CHANCE
MANUFACTURING CO., INC.

Service Information

Ride: SKYDIVER

Subject: CAR BODY FRAME

FIGURE B

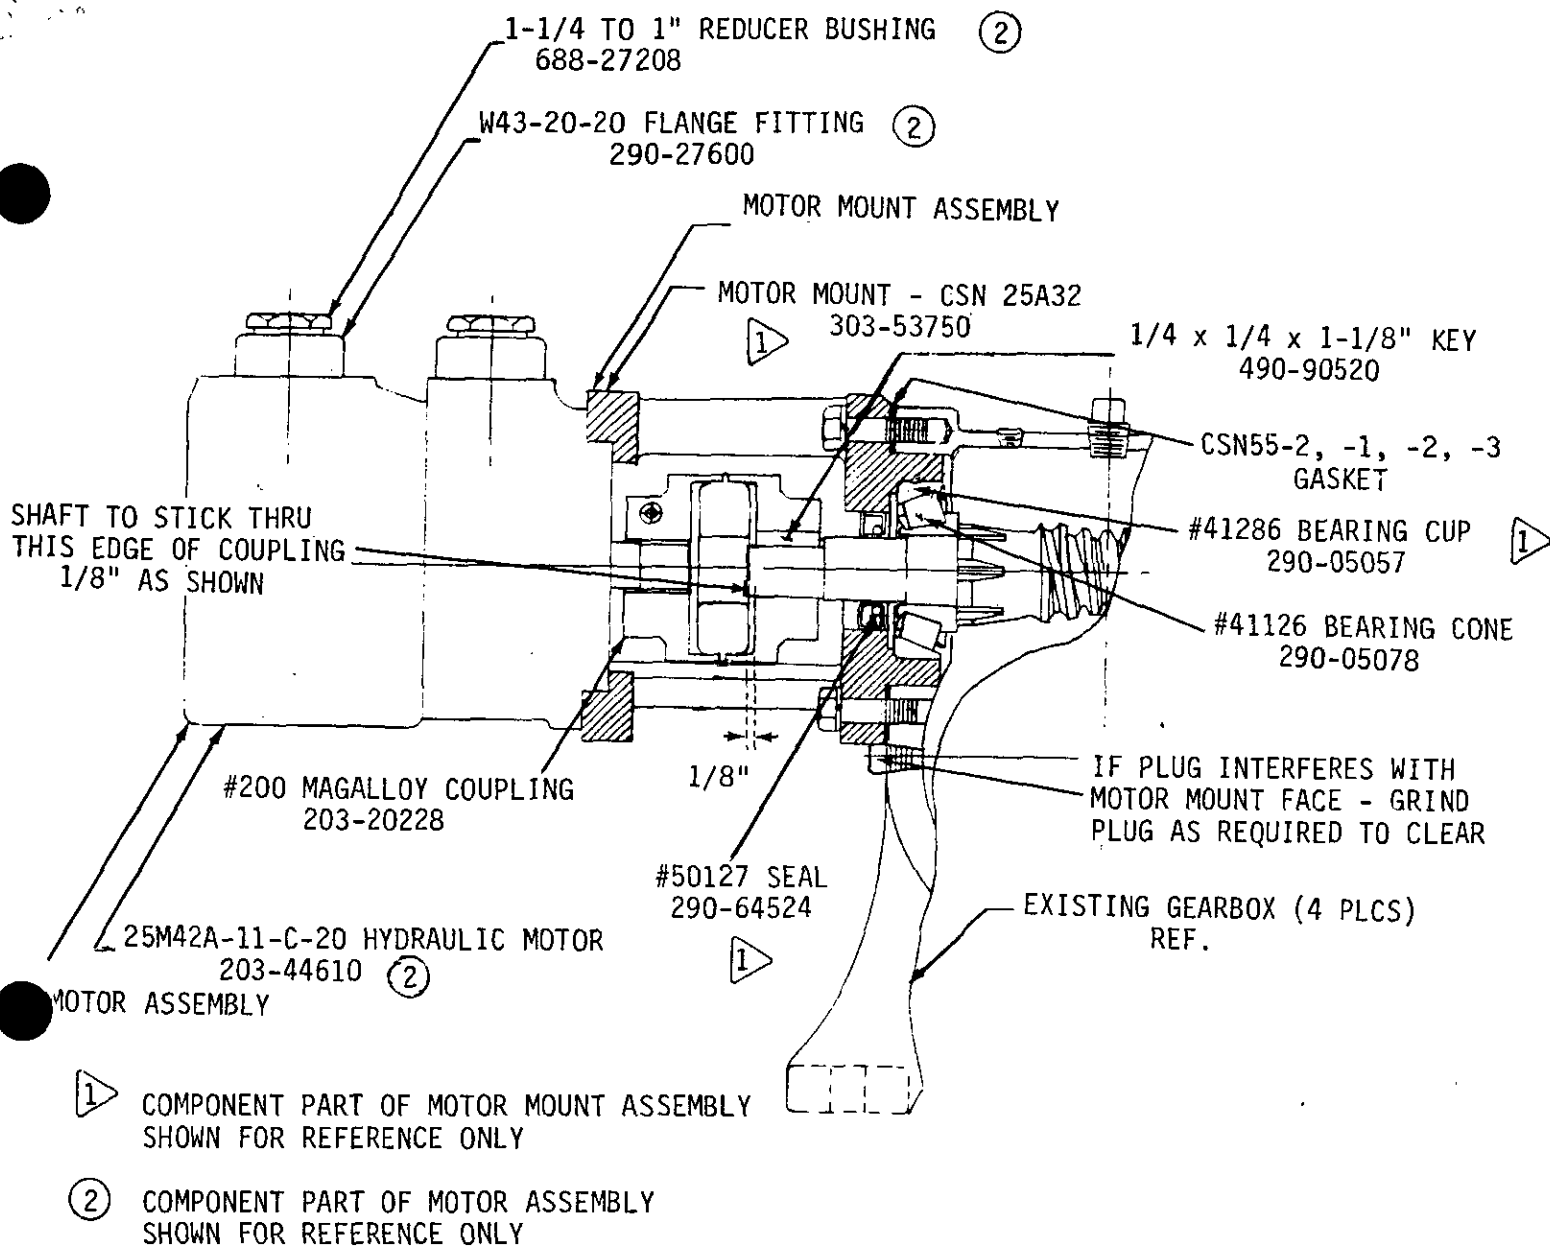
2. Remove existing hydraulic motor, motor mount, couplings, bearing and gaskets from input side of drive gearbox. (SEE FIGURE B)
3. Install new bearing #41126 on input shaft and shim as required between motor mount and gearbox with CSN55-2, -1, -2 and -3 gaskets to adjust input shaft bearings. Use shim thickness of .030 for initial setting. Refer to Cone Drive Assembly Manual for proper adjustment.

NOTE: Index motor mount assembly as required to locate hydraulic motor ports in proper alignment when hydraulic motor is installed.

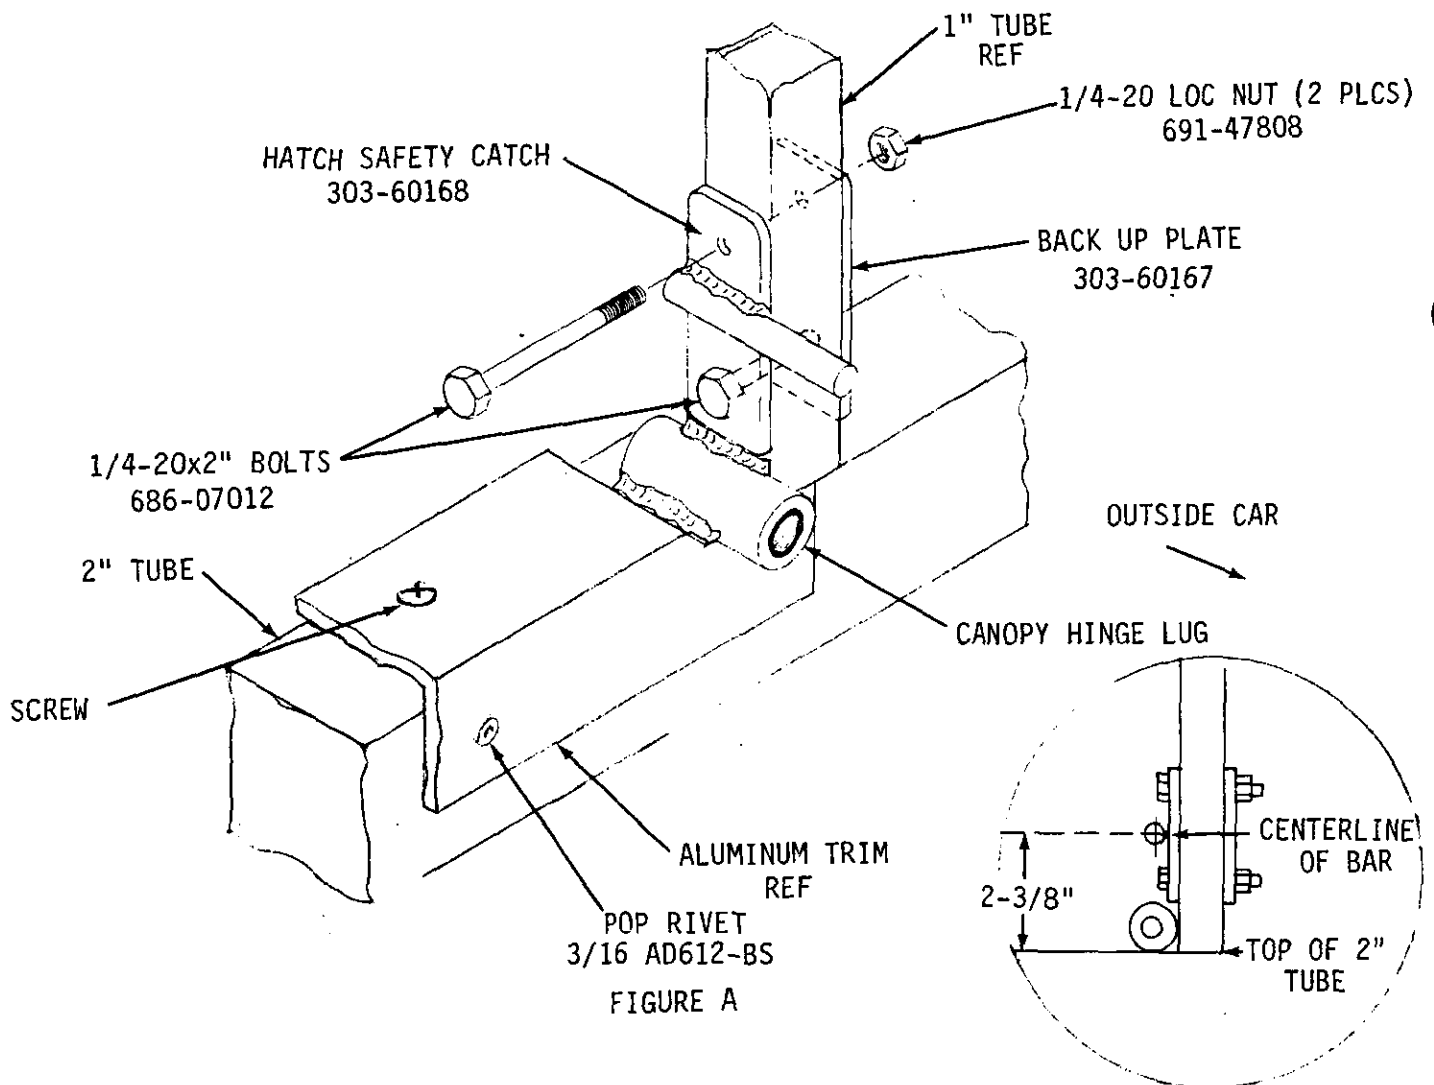
1. Clamp hatch safety catch on 1" tube above hatch hinge with bottom of safety catch resting against the weld of the hatch hinge point and the bar pointing to the outside of the car. (See FIGURE A)

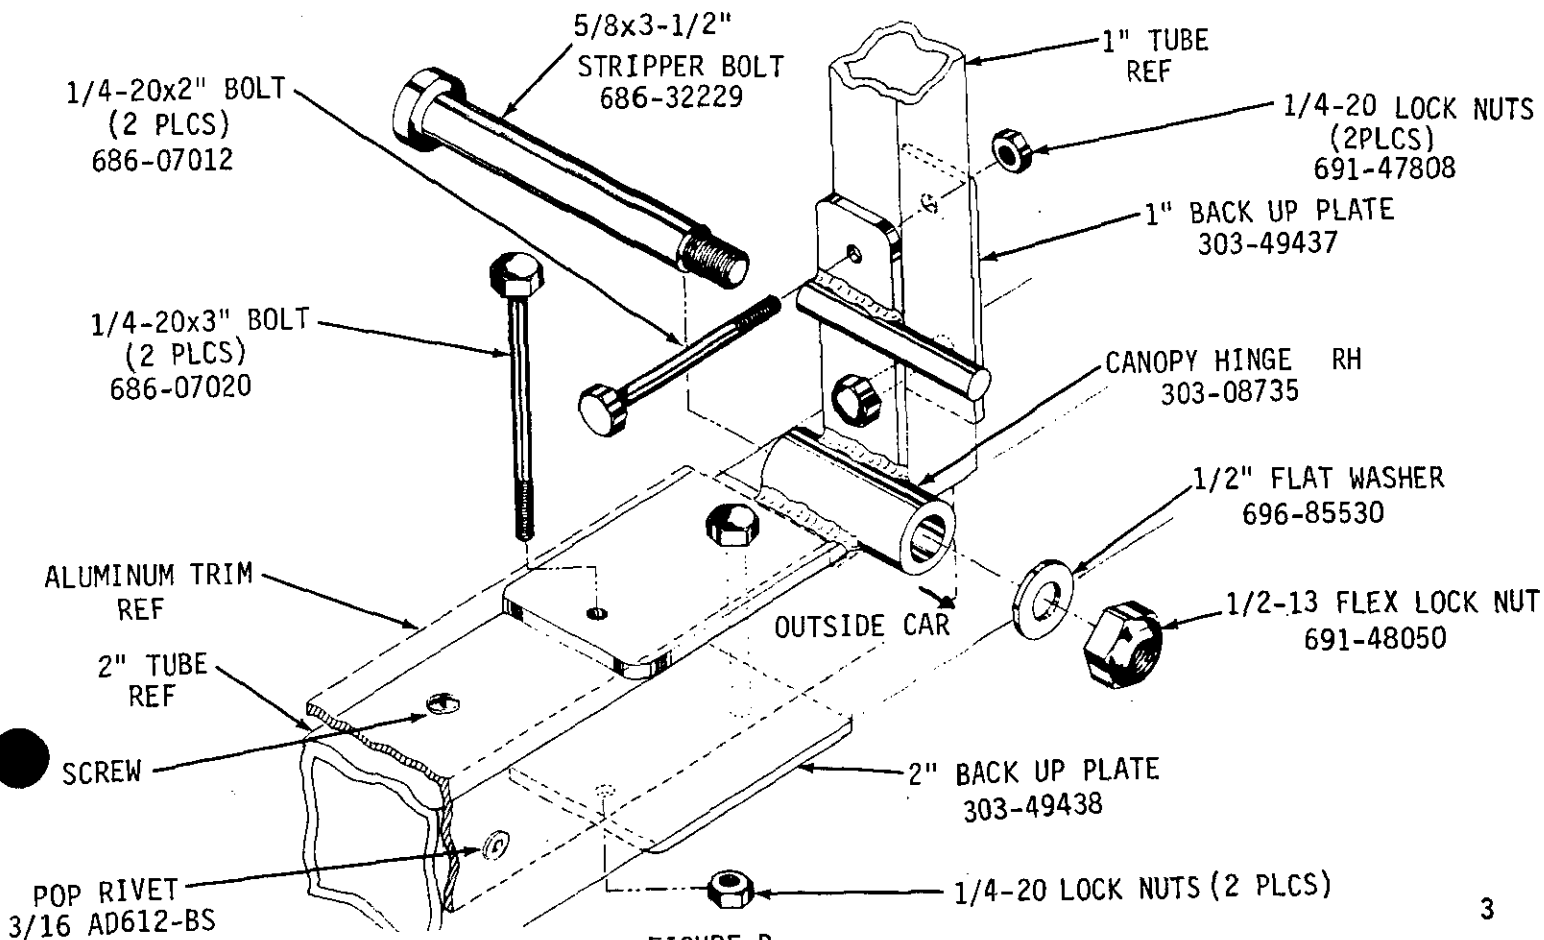
4. Install new hinge to canopy using 5/8x3-1/2" Stripper bolt with flat washer and flex loc nut to the outside of the canopy. (Lubricate stripper bolt, but do not tighten at this time.) (See FIGURE B)

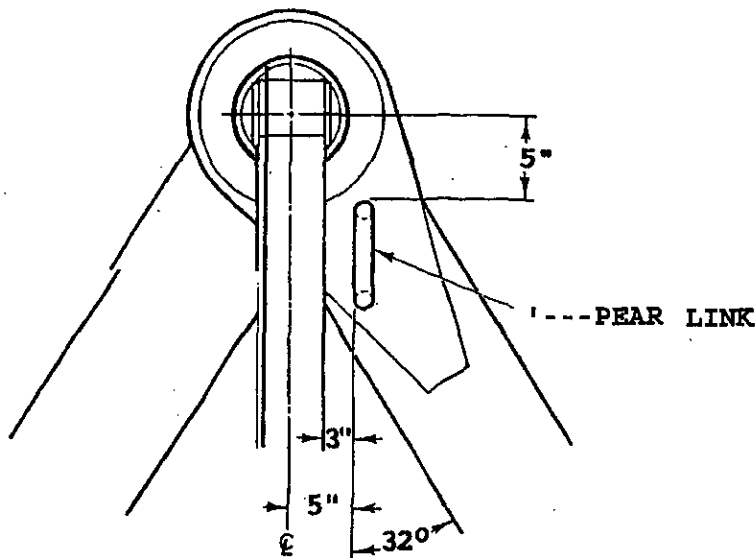
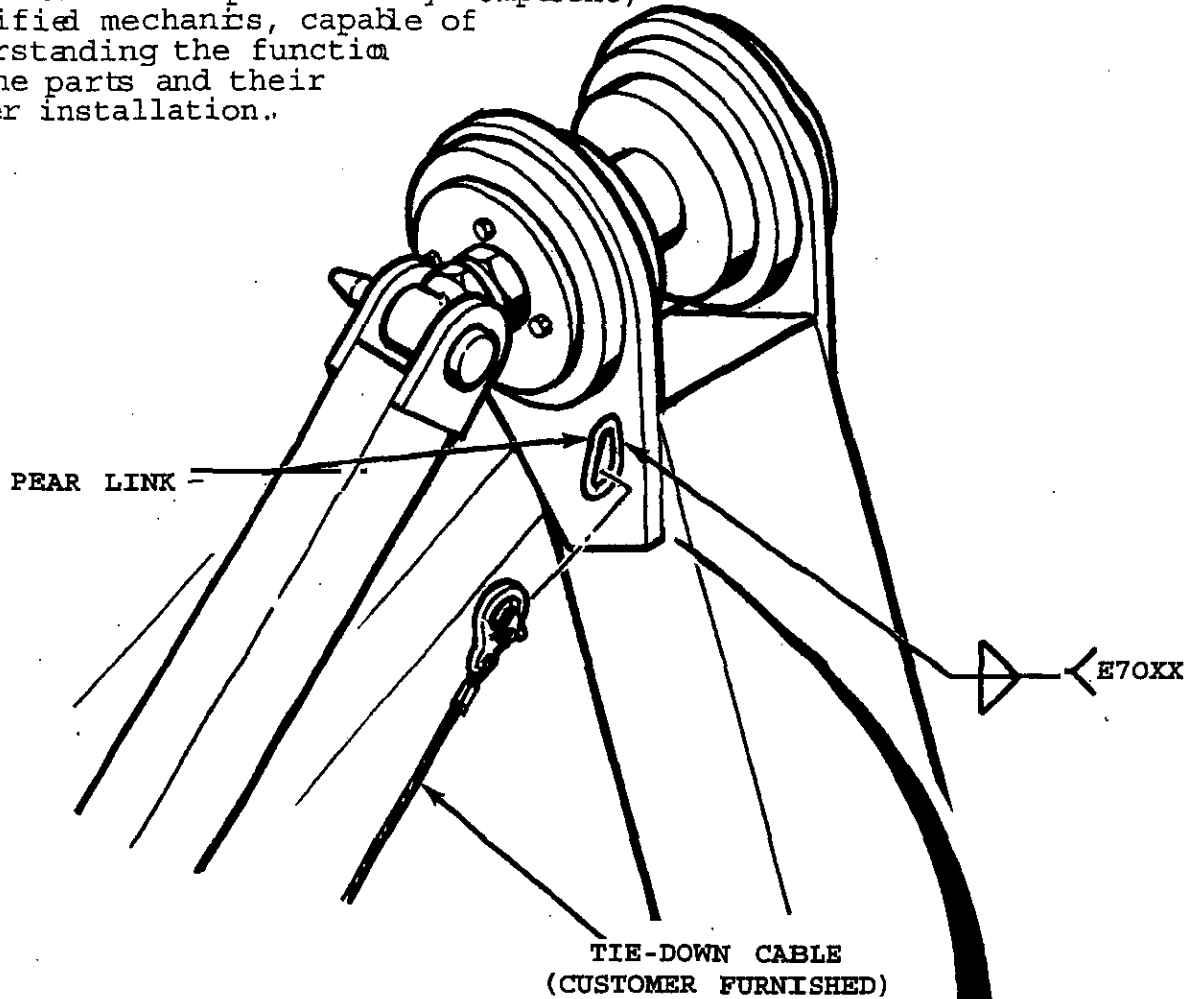
Locate and weld the pear links on each tower leg as shown in the following illustration. All work must be performed by competent, qualified mechanics, capable of understanding the function of the parts and their proper installation.

WRONG

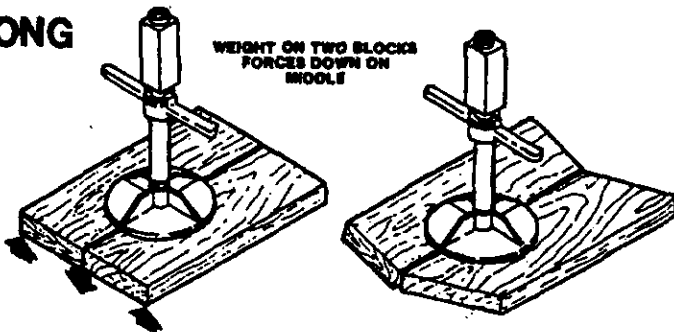
1. Inspect the blocking under each of the four trailer leveling jacks, the four screw jacks and the two outrigger jacks. Good, solid blocking, preferably wooden 3 x 12's, must be placed under each jack point. As blocks are stacked, criss-cross each layer, ending the stack with a single block as shown in the following illustrations.

CORRECT

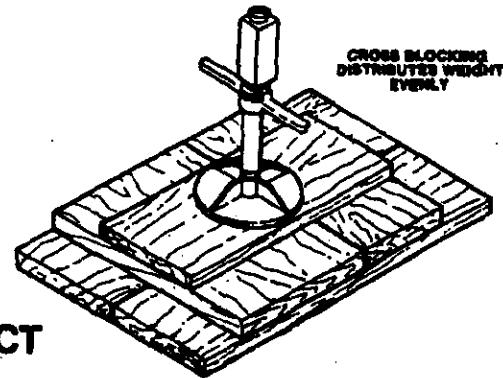
**CROSS BLOCKING
DISTRIBUTES WEIGHT
EVENLY**

TIE DOWN CABLE
(CUSTOMER FURNISHED)

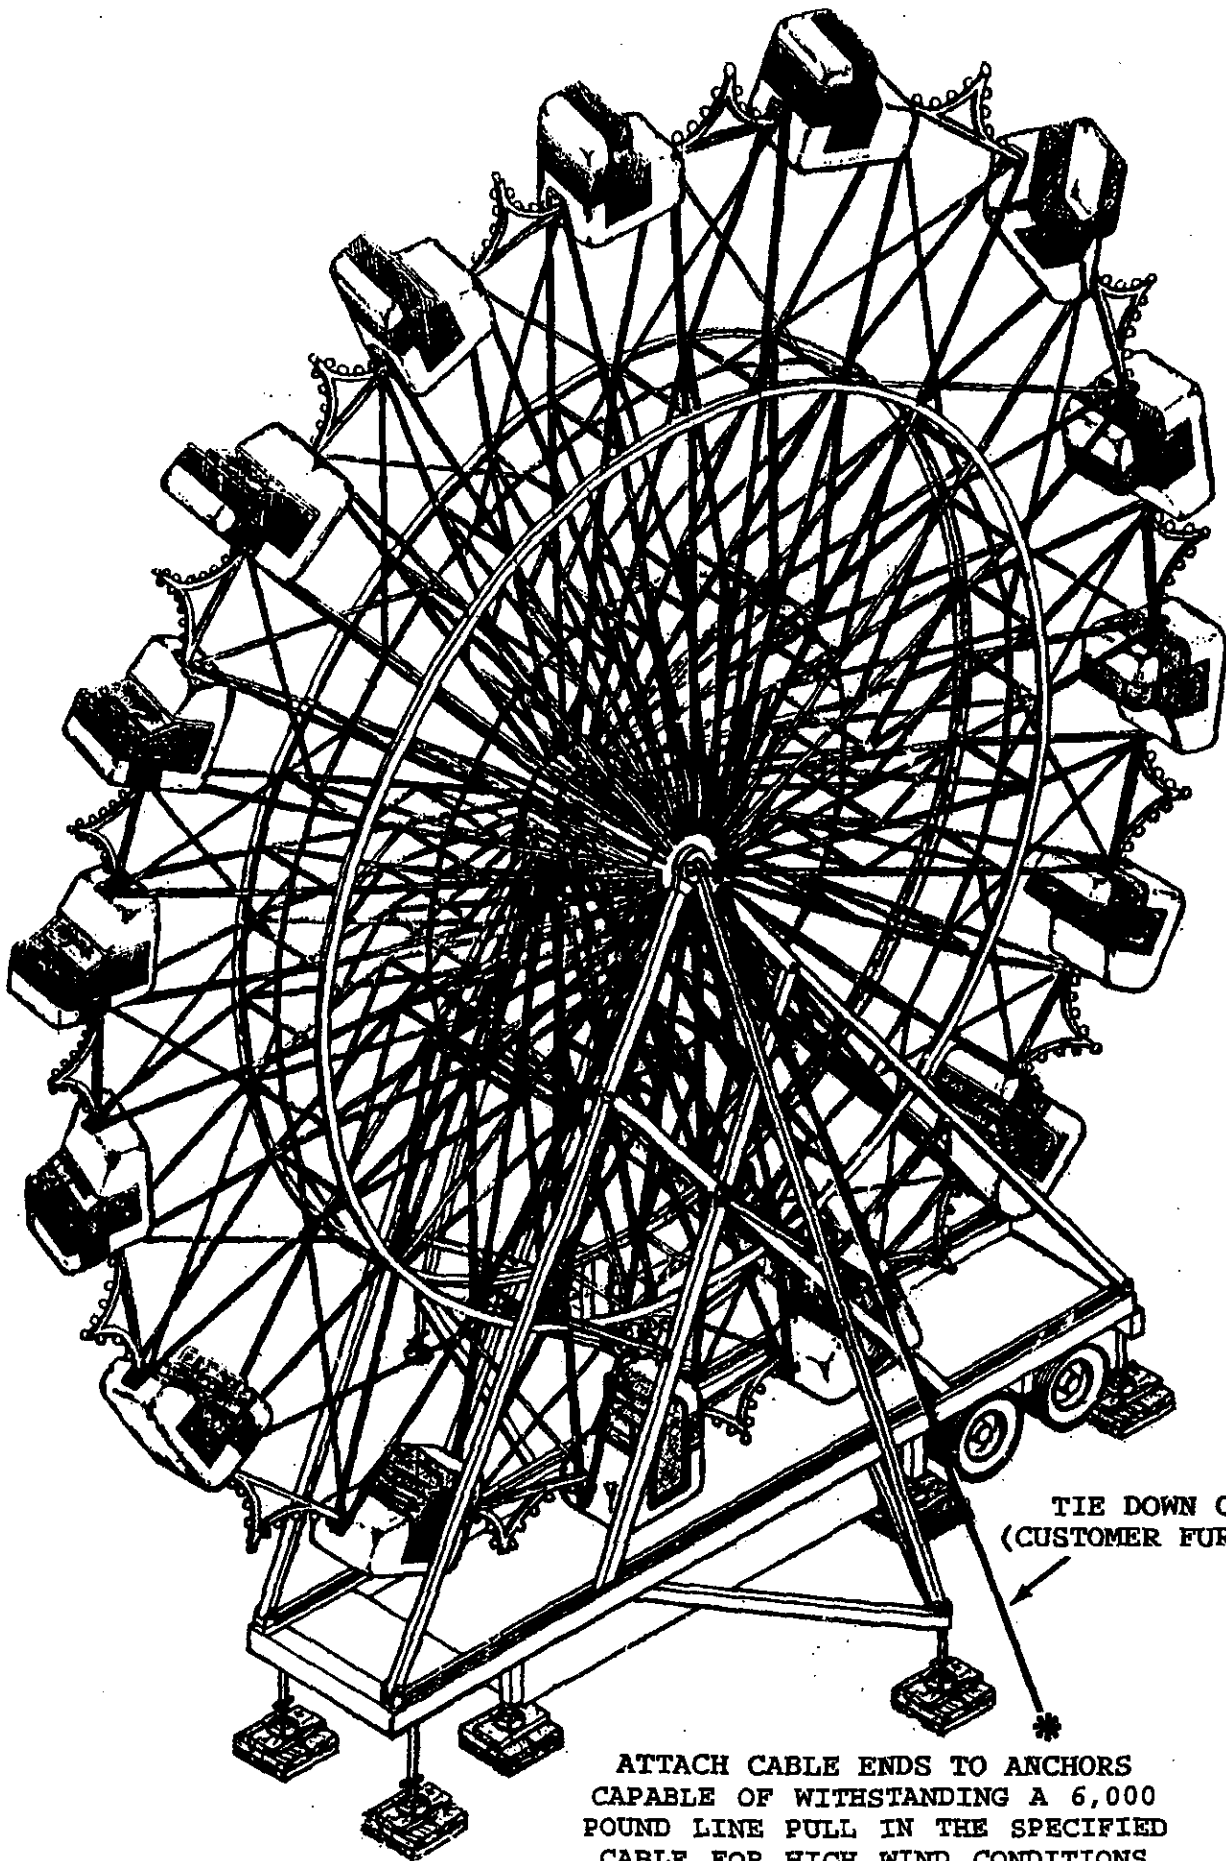
1. Attach cables to the pear links on the tower legs. Attach the other end of each cable to anchors capable of withstanding a 6,000 pound line pull in the specified cable. (See illustration on next page).
2. Tighten the cables until snug.

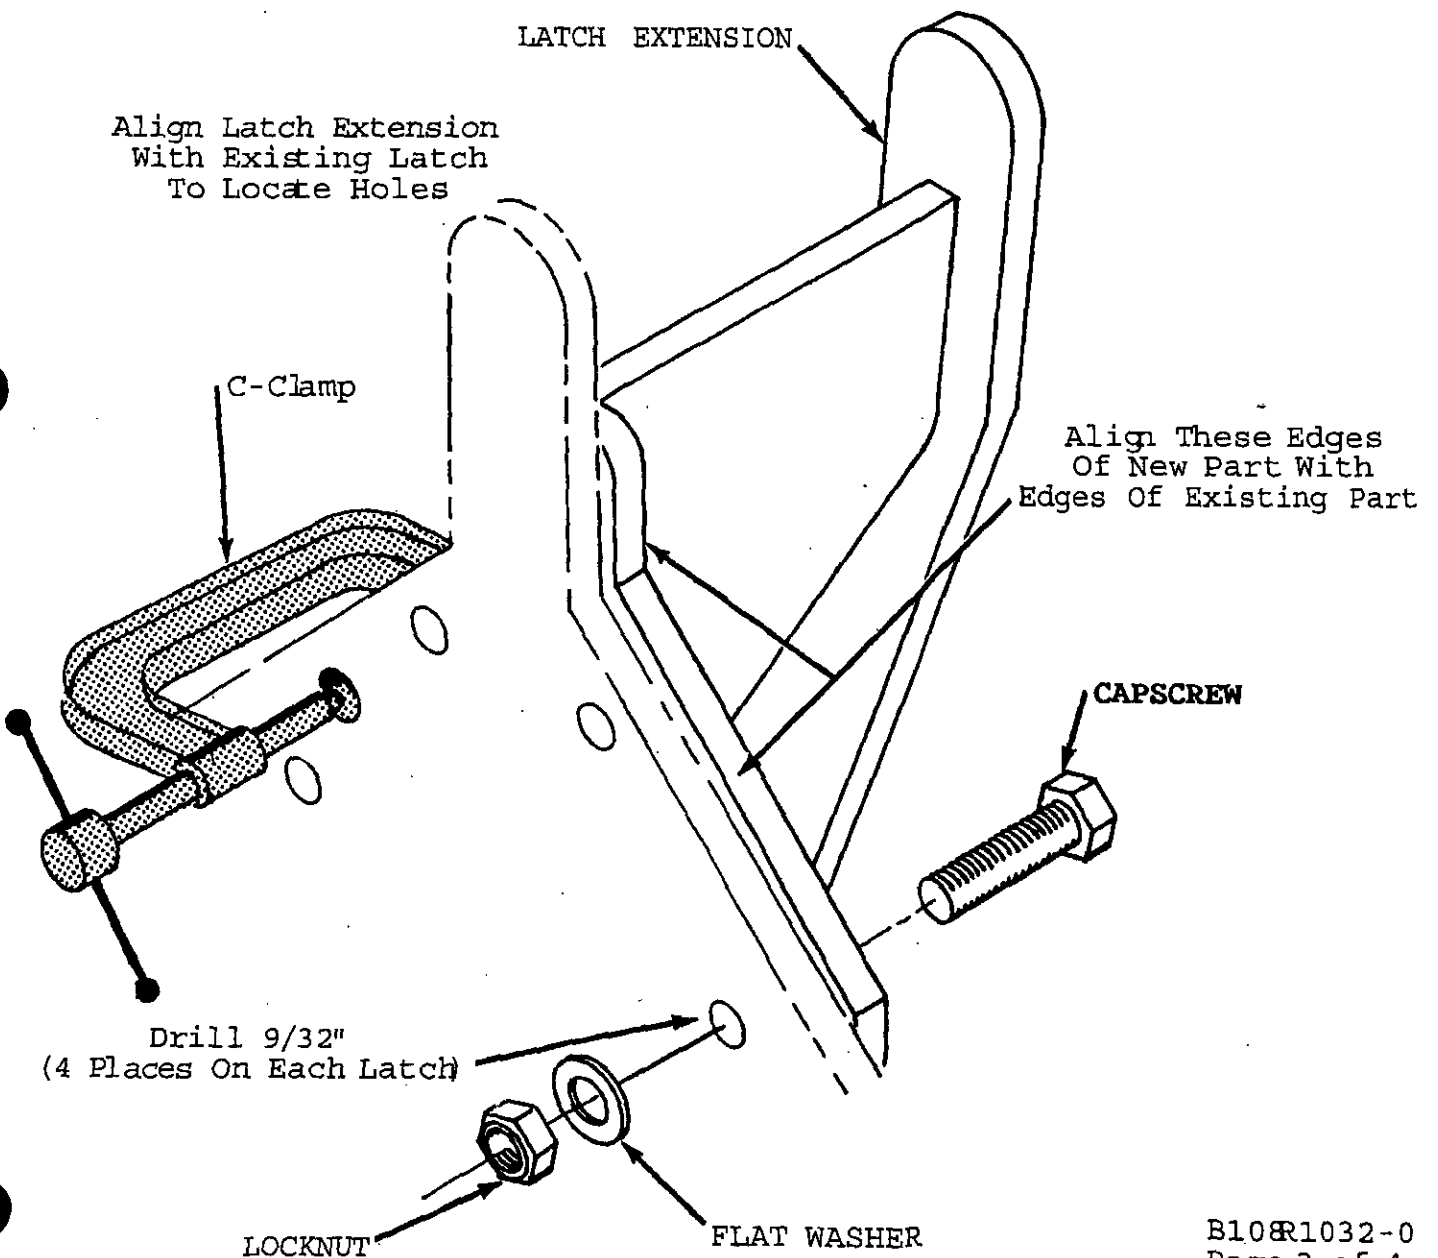
1. Align the edges of latch extension (Item #1) with the edges of the existing latch as shown in the illustration below.
2. Use a C-clamp to hold the latch extension in place as shown.
